Project	IEEE 802.16 Broadband Wireless Access Working Group < http://ieee802.org/16 >	
Title	STC Enhancements for optional FUSC and AMC zones for OFDMA PHY Layer	
Date Submitted	2004-05-15	
Source(s)	Wonil Roh, Seungjoo Maeng, Jiho Jang, Panyuh Joo, Jaeho Jeon, Soonyoung Yoon Samsung Electronics Co., Ltd. Dong Suwon P.O.Box 105 416, Maetan-3dong, Yeongtong-gu, Suwon-city, Gyeonggi-do, Korea 442-600	wonil.roh@samsung.com Voice: +82-31-279-3868
Re:	Sponsor re-circulation Ballot	
Abstract	STC enhancements for the optional AMC and FUSC for the downlink	
Purpose	Adoption of proposed changes into P802.16e	
Notice	This document has been prepared to assist IEEE 802.16. It is offered as a basis for discussion and is not binding on the contributing individual(s) or organization(s). The material in this document is subject to change in form and content after further study. The contributor(s) reserve(s) the right to add, amend or withdraw material contained herein.

STC Enhancements for Optional FUSC and AMC Zones for OFDMA PHY Layer

2 Specific Text Changes

Figure vvy-1 Pilot allocation method #1

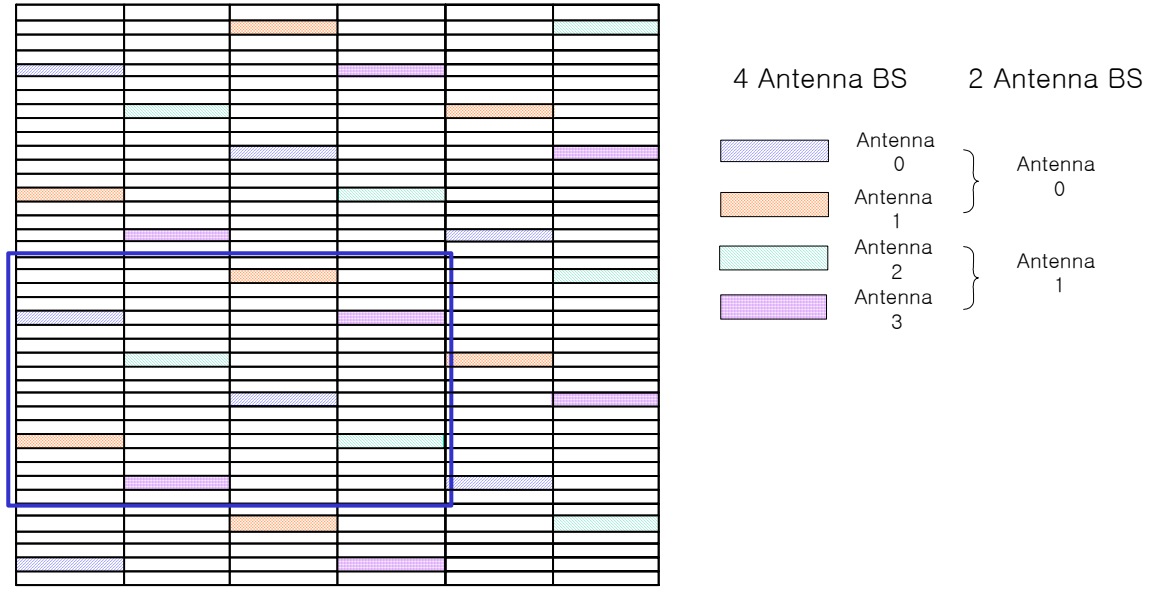
Method 1: use of disjoint pilot sets

Pilots are split into 2 or 4 disjoint sets. For 2-antenna BS, all pilots in the even symbols allocated for Ant 0 whereas all pilots in the odd symbols used for Ant 1. For 4-antenna BS, pilots in the even symbols are further split for Ant 0 and 1, while those in the odd symbols split for Ant 2 and 3. See Figure yyy-1.

Figure vvy-2 Pilot allocation method #2

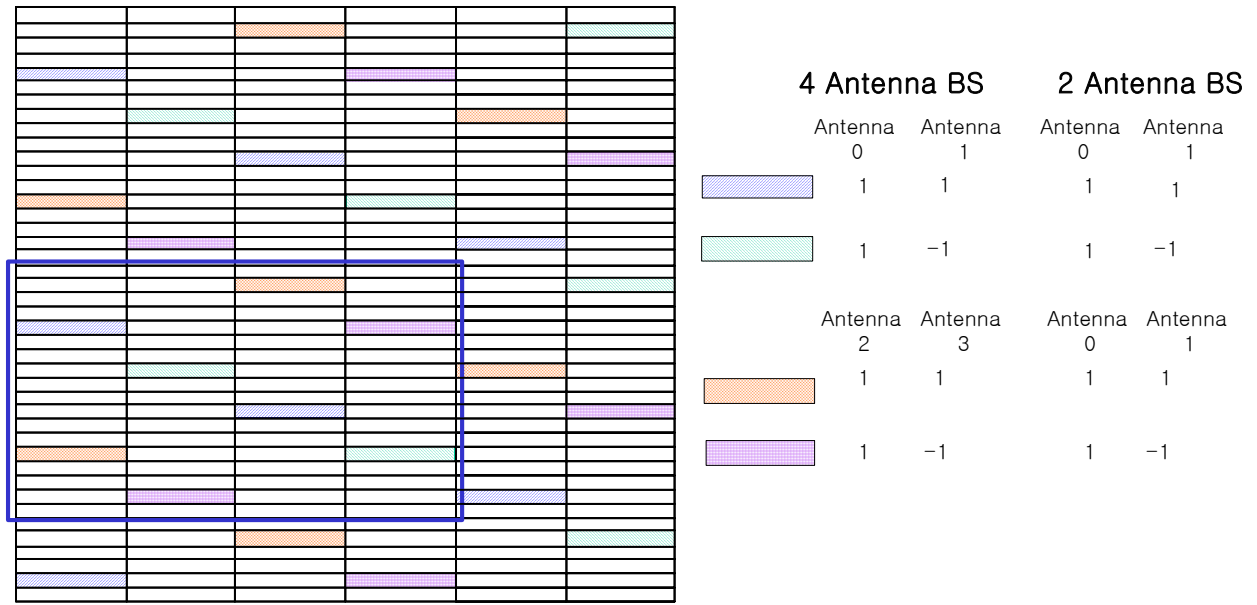
Method 2: use of orthogonal sequence on pilots

Pilots are shared with 2 or 4 antennas to increase the granularity and their orthogonality is maintained by the simple block code as shown in Figure yyy-2.
